**Re: Ontario Energy Board (OEB) Staff Interrogatories  
Hydro One Networks Inc. (Hydro One)  
2023-2027 Joint Rate Application (JRAP)  
OEB File Number: EB-2021-0110**

**HYDRO ONE NETWORKS INC.**  
**2023-2027 JOINT RATE APPLICATION**  
**EB-2021-0110**  
**OEB STAFF INTERROGATORIES**  
**October 26, 2021**

**Figure 3 – Transformer Fleet Condition Assessment**

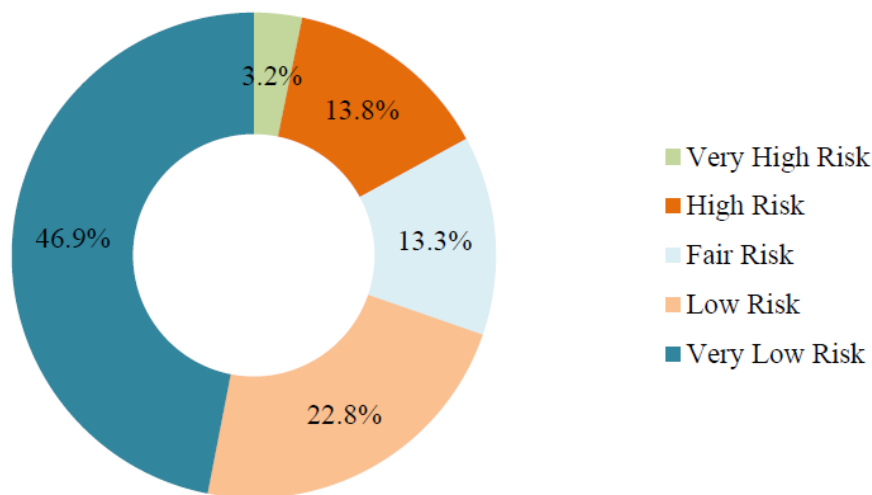
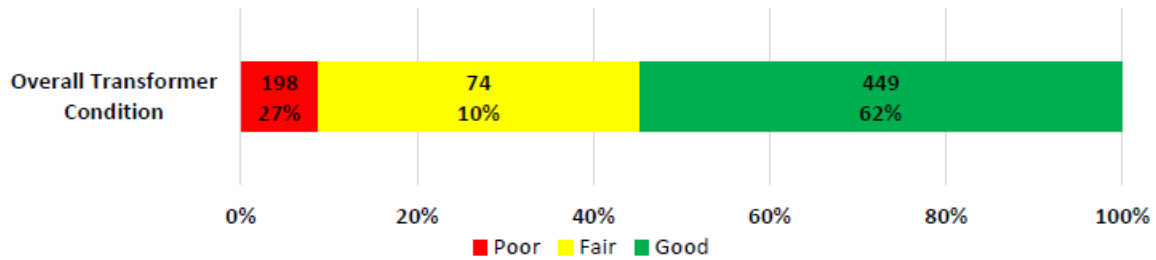
The first reference, from the EB-2019-0082 application, contains the following breakdown of transformer condition:

Footnote 3 at the second reference (current application) states that:

In the prior transmission application (EB-2019-0082, TSP Section 2.2, p. 8), the 122 (17%) transformers identified as being in poor condition reflected the main tank oil tests results only at a point in time, and not the other condition indicators as discussed below. Based on Hydro One's detailed transformer condition assessments, the number of poor condition transformers at the time of the prior application would have been 181 (as noted above). Similarly the 2016 values displayed in Figure 1 above have been updated to 116 based on the detailed transformer condition assessment whereas the values shown in the rate application were solely based on the main tank oil assessment at a point in time (EB-2016-0160). It is important to note that Hydro One's approach for assessing transformer condition (and for prioritizing replacements) has not changed since the last rate application.

- a) Please explain how the information presented in Figure 3 (first reference), which uses the categories Very High Risk, High Risk, Fair Risk, Low Risk, and Very Low Risk; corresponds to 17% of transformers being identified as being in poor condition.
- b) Please explain how Hydro One has increased the number of poor condition transformers at the time of the prior application (from 122 to 181) if Hydro One's approach for assessing transformer condition has not changed.

**B3-Staff-139**

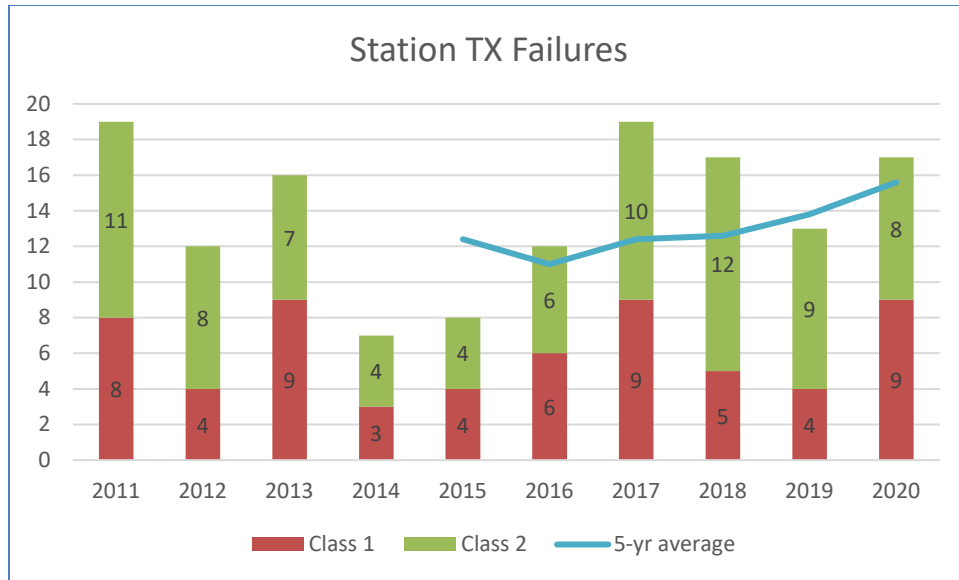
The following table and chart reproduce the station transformer failure information contained in Figure 3 at the first reference. The five-year average of station transformer failures is increasing with time.
